To: Miller SkyGrip Temporary Horizontal Lifeline System Distributors/End-Users

From: Honeywell Personal Protective Equipment

Subject: IMMEDIATE MANDATORY INSPECTION NOTICE

Figure 1: Picture of properly 5-sided weld stanchion pocket to base

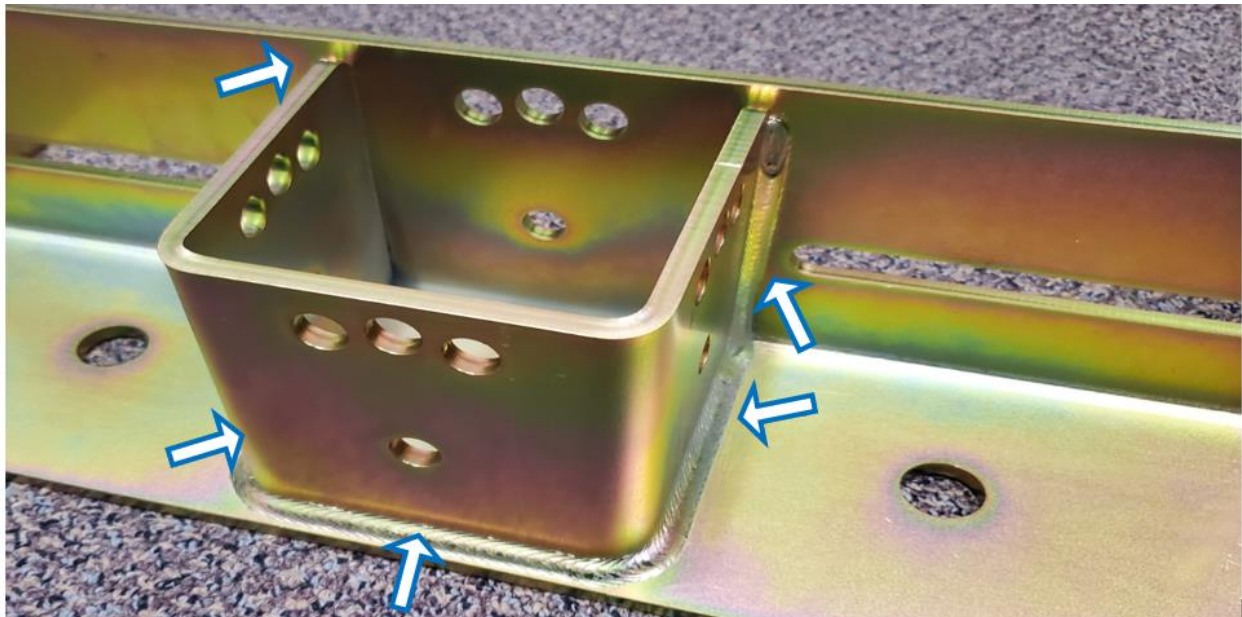
At Honeywell, our mission is to continue to provide innovative personal protective equipment that helps our customers maintain workforce safety. You have been identified as a customer that has purchased the Miller SkyGrip Temporary Horizontal Lifeline System that were manufactured by Honeywell between **2010-2018**. Honeywell has identified a potential issue with the rebar base assembly, particularly, the stanchion pocket (see Fig 1 below) that may cause the product to not operate to specification.

Step 1. Visually inspect the rebar base assembly stanchion pocket for a complete five-surface weld of the pocket to the base. (See Figure 1).

Step 2. If the stanchion pocket is not properly welded on all five sides, to the base, as shown in Figure 1, immediately decommission the use of the of the system base and contact Honeywell Customer Service to arrange a replacement.
